NO. 25
 MAY 12, 1947

FIELD SERVICE BULLETIN

SUBJECT: STARTER ENGAGING MECHANISM REWORK

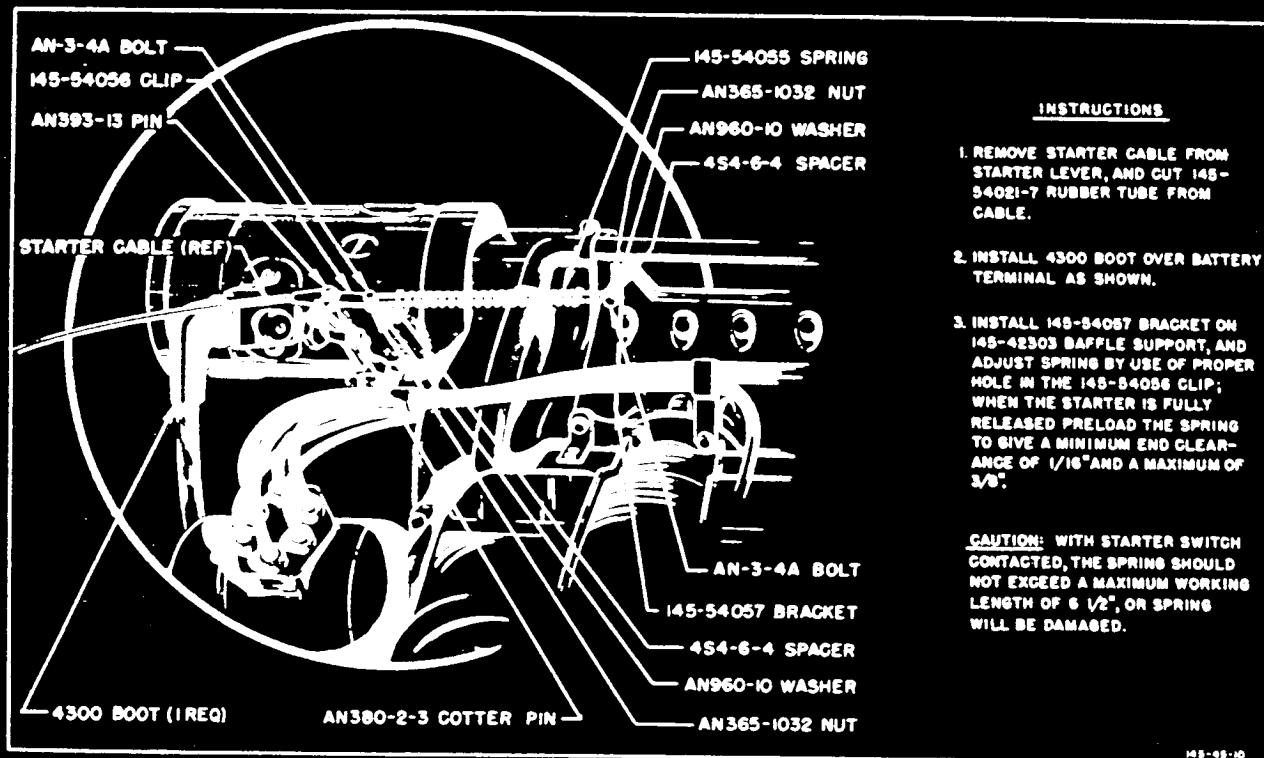
To prevent the starter mechanism from remaining engaged after the engine has started, an additional starter return spring is necessary. The required parts furnished in 145-89033 Kit, are installed as follows:
